TO:	FROM:
ALL BIDDERS	Luis Ponce, P.E.
COMPANY:	DATE:
	October 5, 2020
ADDRESS:	TOTAL NO. OF PAGES INCLUDING COVER:
	16
RE:	
City of Ferndale	
Addendum 1	
Complete Streets Project	
City Project Number ST2019-02	
TIB Project Number C-W-985(001)-1

**ADDENDUM NO. 1**  
**To the Contract Provisions for**  
**CITY OF FERNDAL, WASHINGTON**

**Complete Streets Project**  
**City Project Number ST2019-02**  
**TIB Project Number C-W-985(001)-1**

3

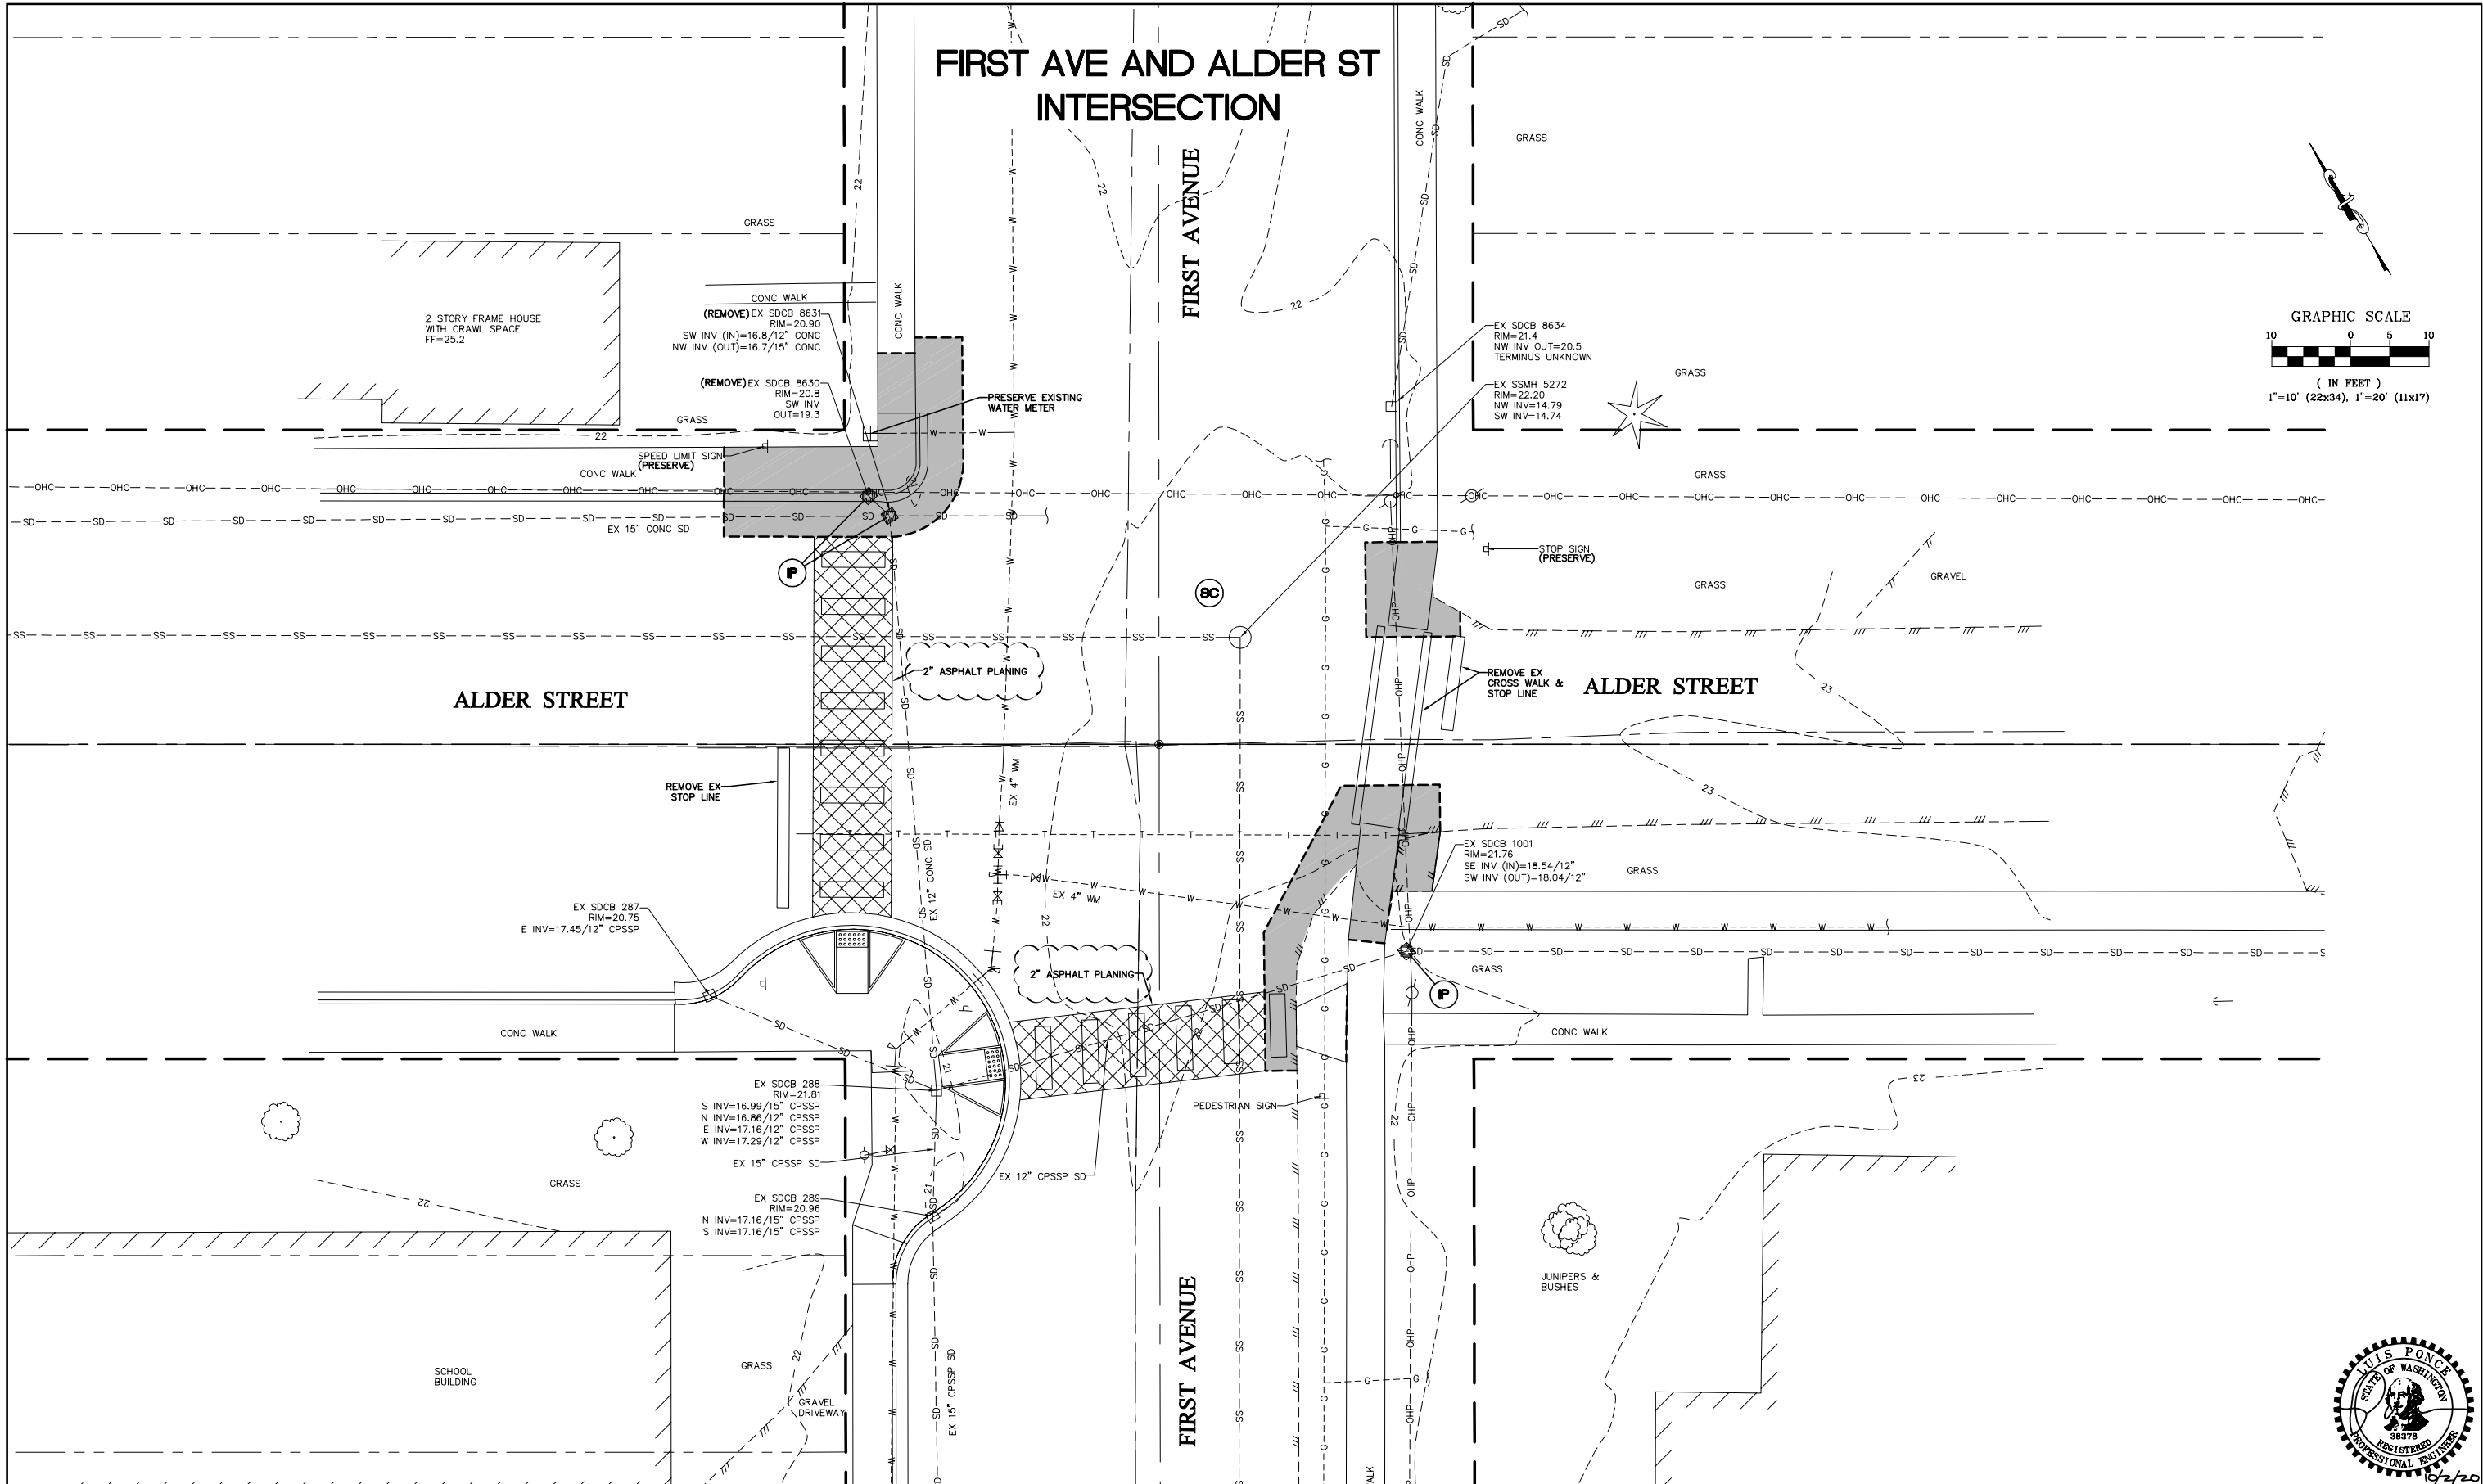
##### Sheet 3

- 2" asphalt planing labels were added for clarity.

DATE 10/2/20  
SHEET 7 of 23

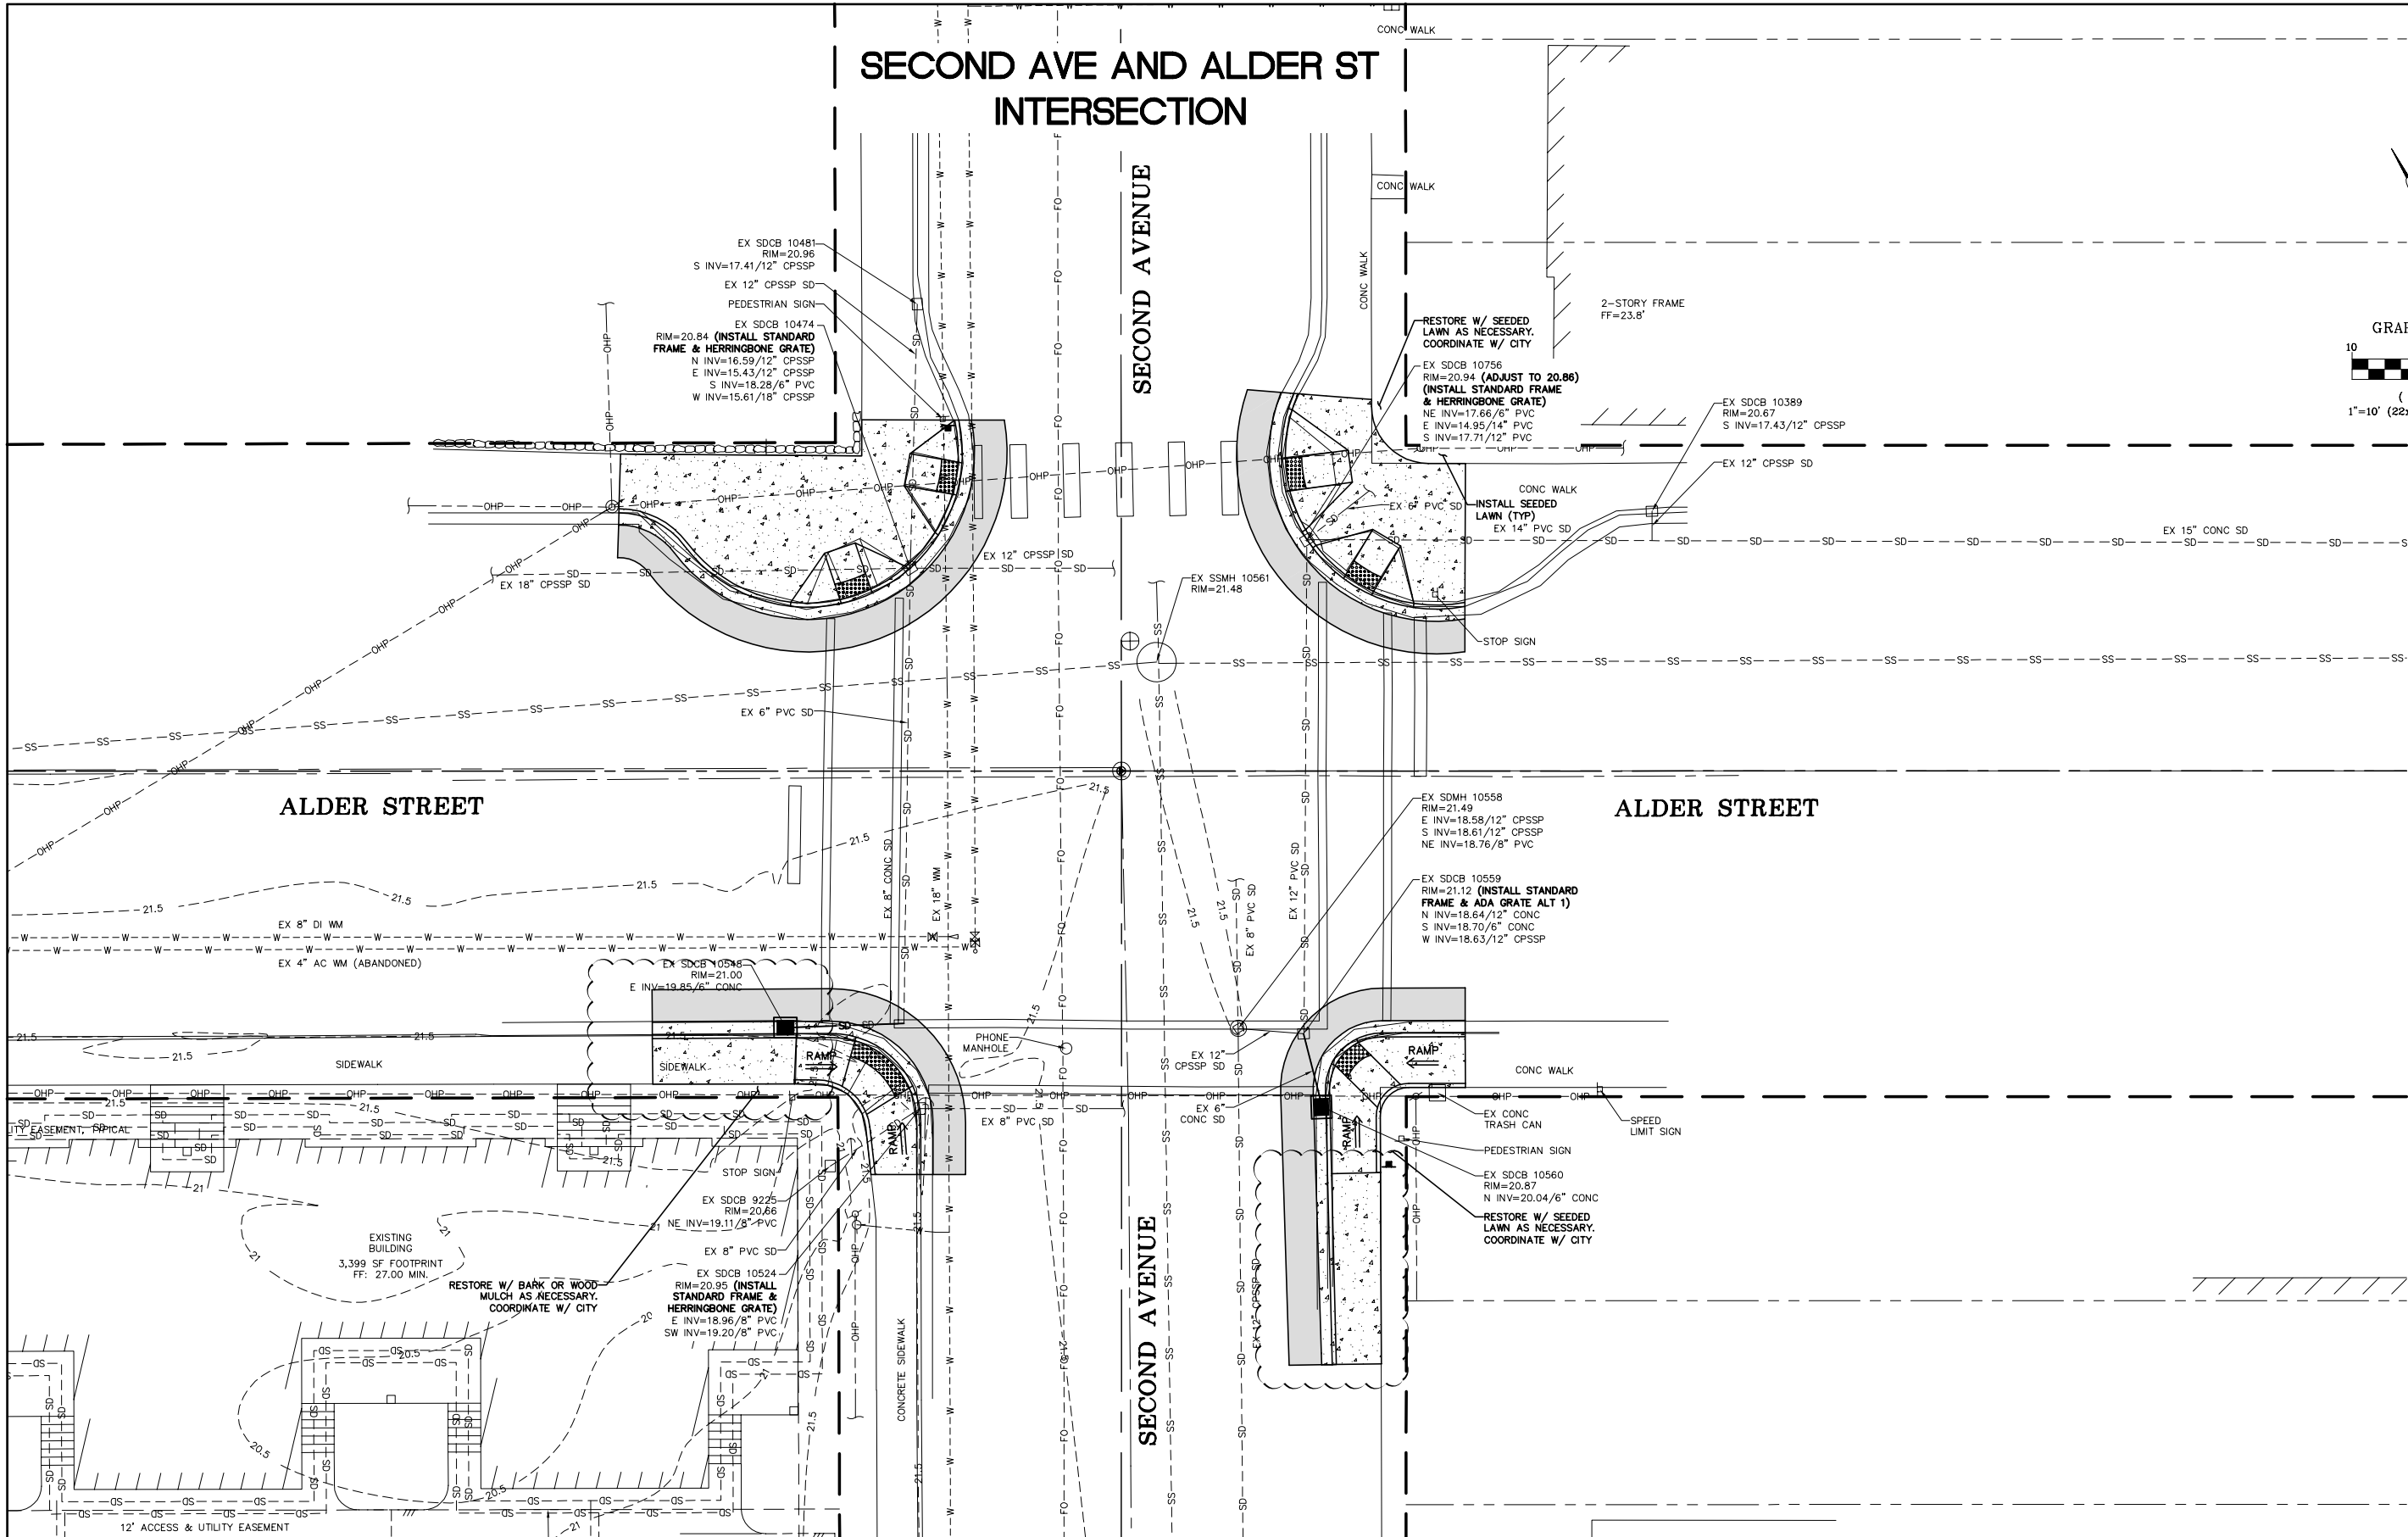
##### Sheet 7

- Sidewalk, curb and gutter, and asphalt were extended on southwest and southeast corners of the intersection.
- Existing maple tree removed from southeast corner of intersection (outside of right-of-way).

DWG	19024 PLOT	DATE	10/2/20
JOB#	19024	SCALE	H: 1"=10' V: N/A
SHEET	8	of 23

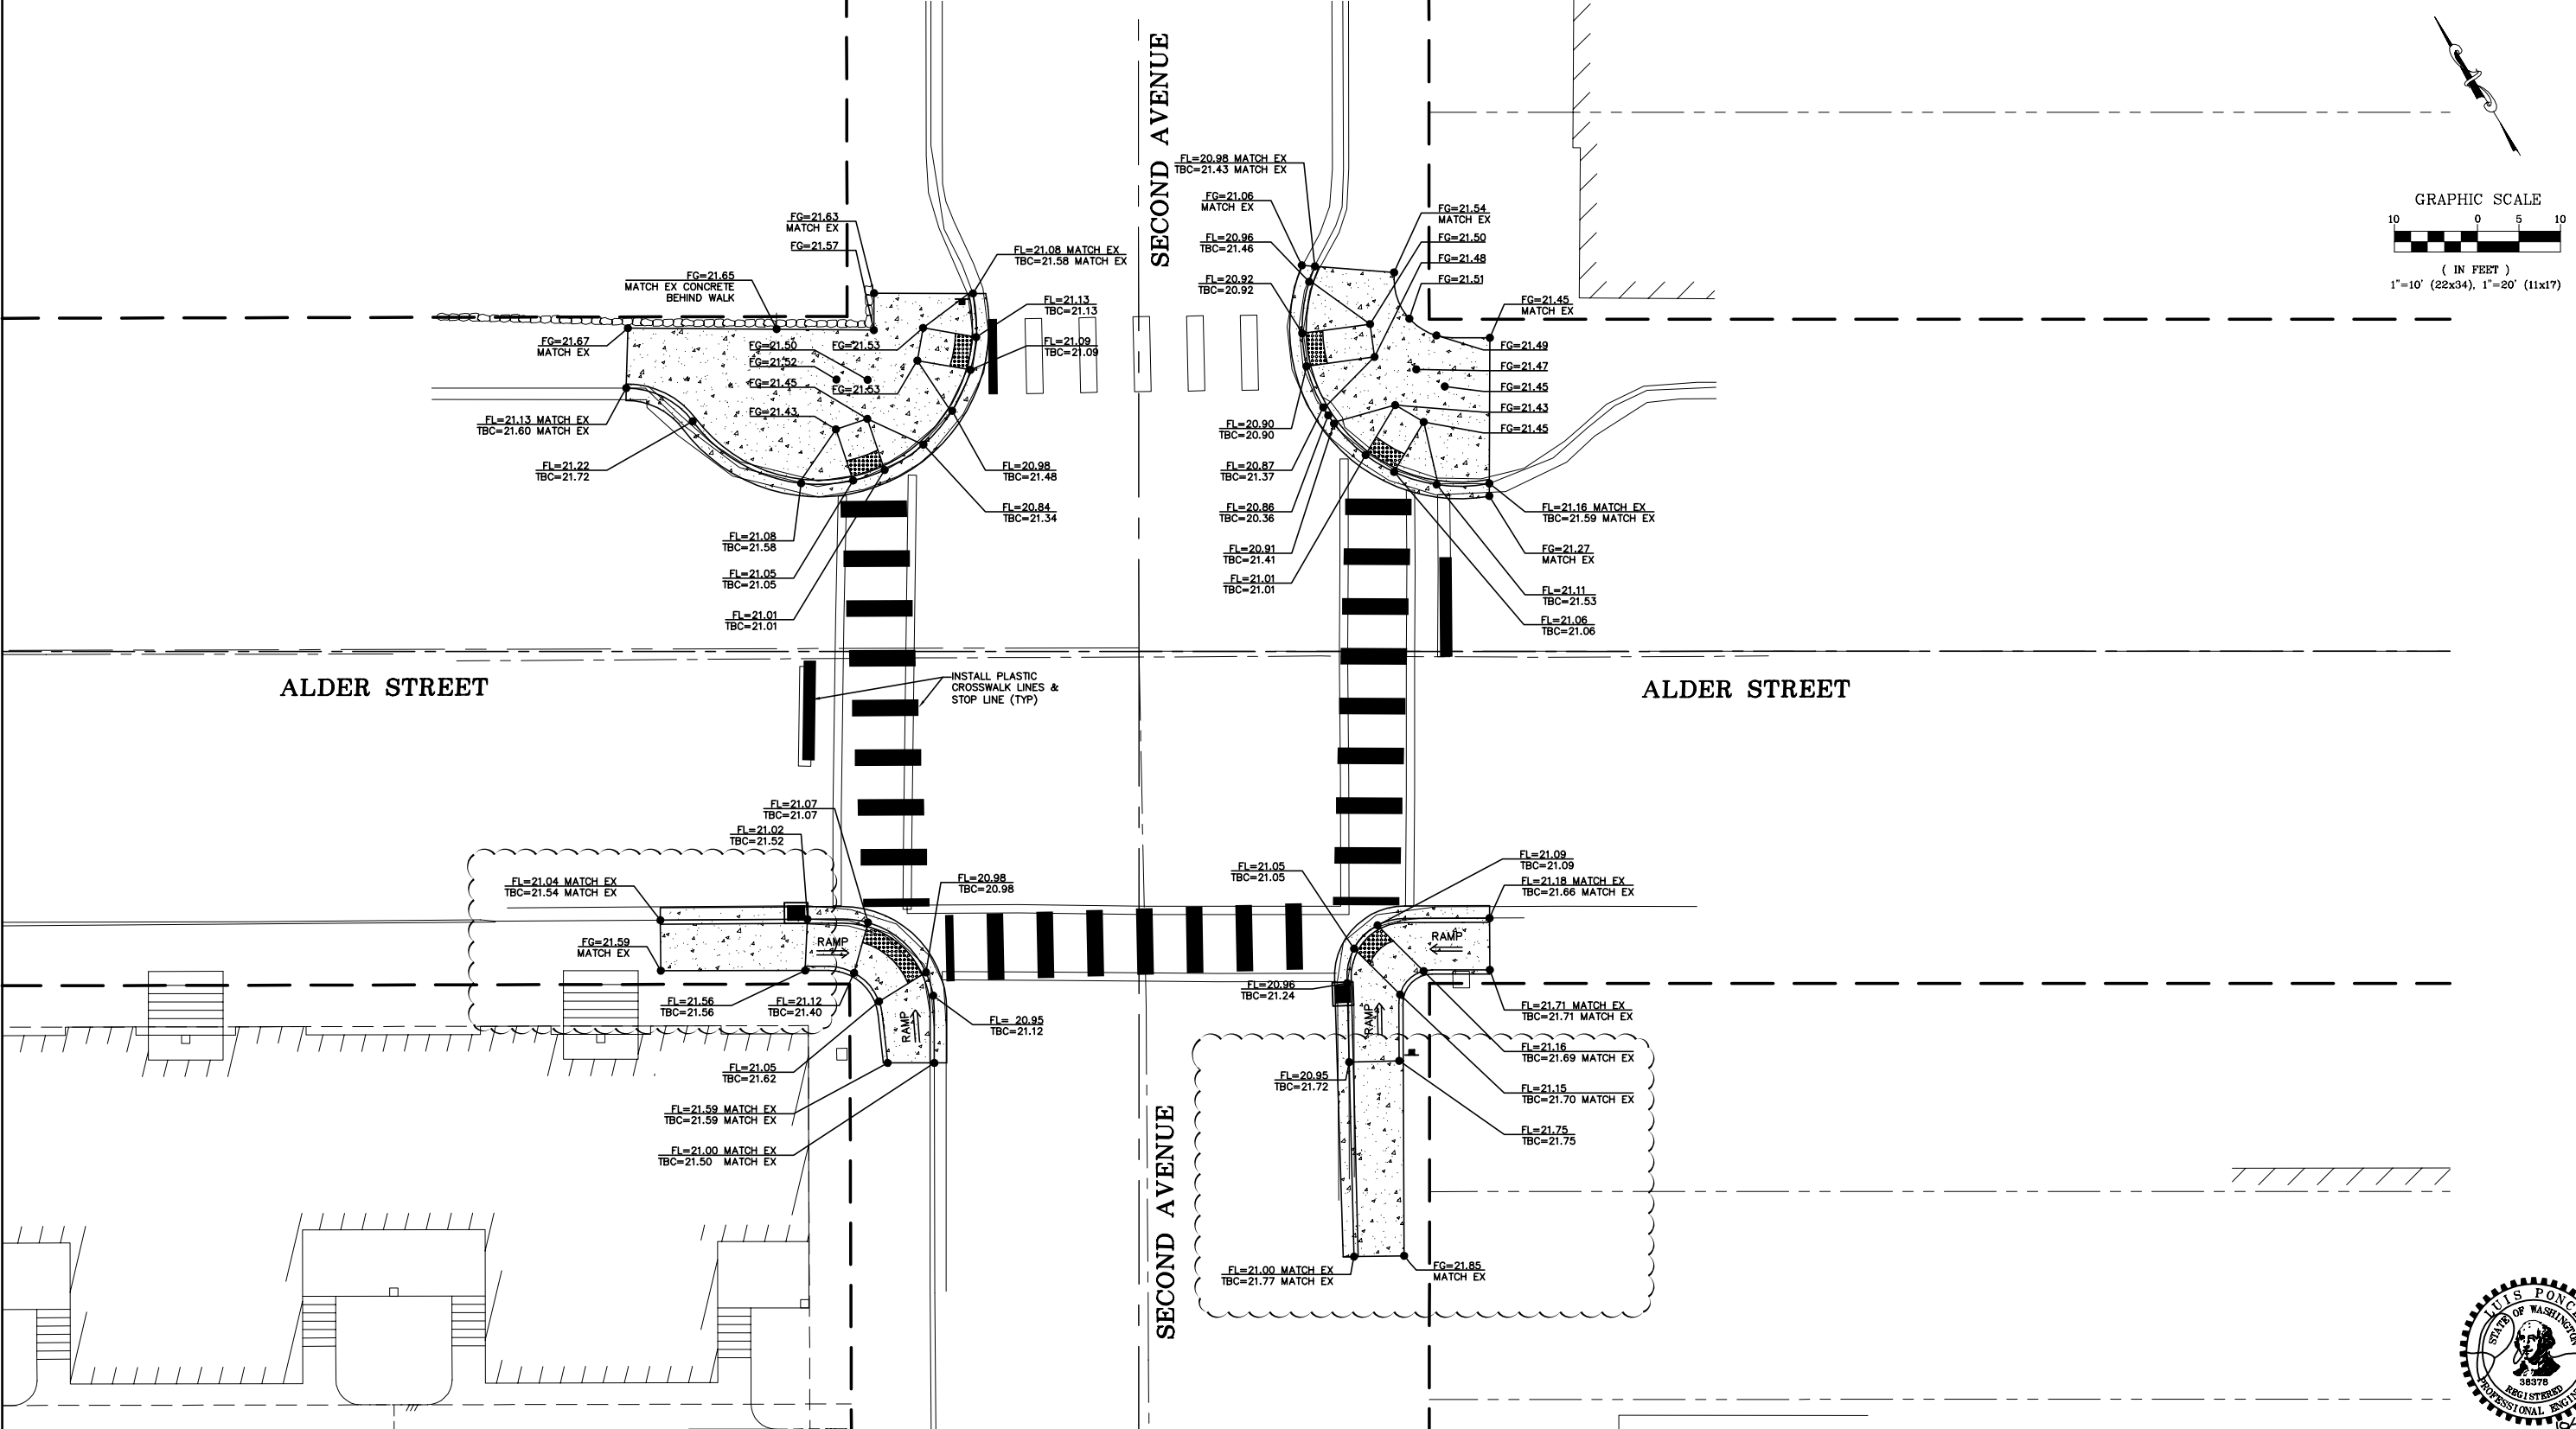
##### Sheet 8

- Updated grade ticks for extended sidewalk, curb and gutter, and asphalt on southwest and southeast corners of the intersection.
- Existing maple tree removed from southeast corner of intersection (outside of right-of-way).
